RULE NO.: R161-21.28

NOTICE OF RULE ADOPTION

R161-21.28: Modifies the Standards Manual to align with the Environmental Criteria Manual 1.6.4(A) as follows:

Standards Manual: SERIES 500 - PIPE AND APPURTENANCES.

661-2

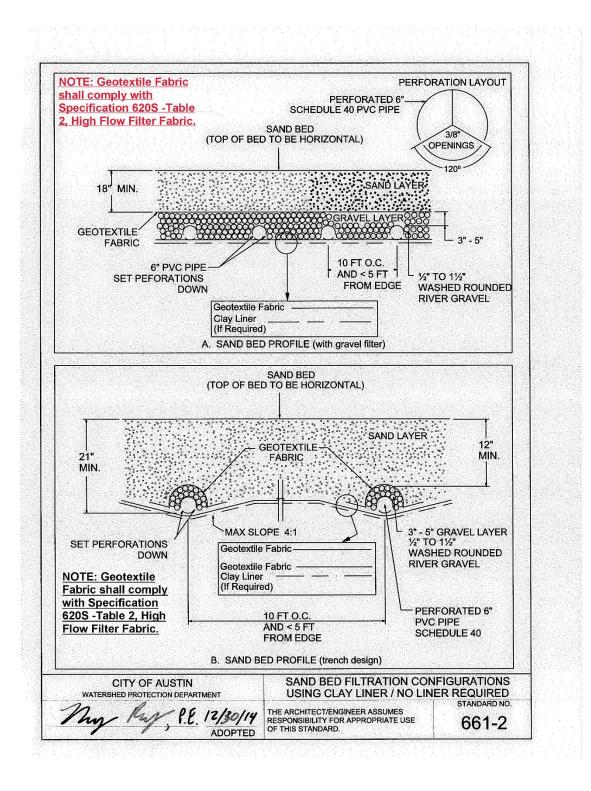
- <u>Standard No. 661-1</u> Changes fabric specification to match geotextile fabric requirement in ECM 1.6.5(A)(4) ("High Flow Filter Fabric").
- <u>Standard No. 661-2</u> Changes fabric specification to match geotextile fabric requirement in ECM 1.6.5(A)(4) ("High Flow Filter Fabric").
- <u>Standard No. 661-3</u> Changes fabric specification to match geotextile fabric requirement in ECM 1.6.5(A)(4) ("High Flow Filter Fabric").
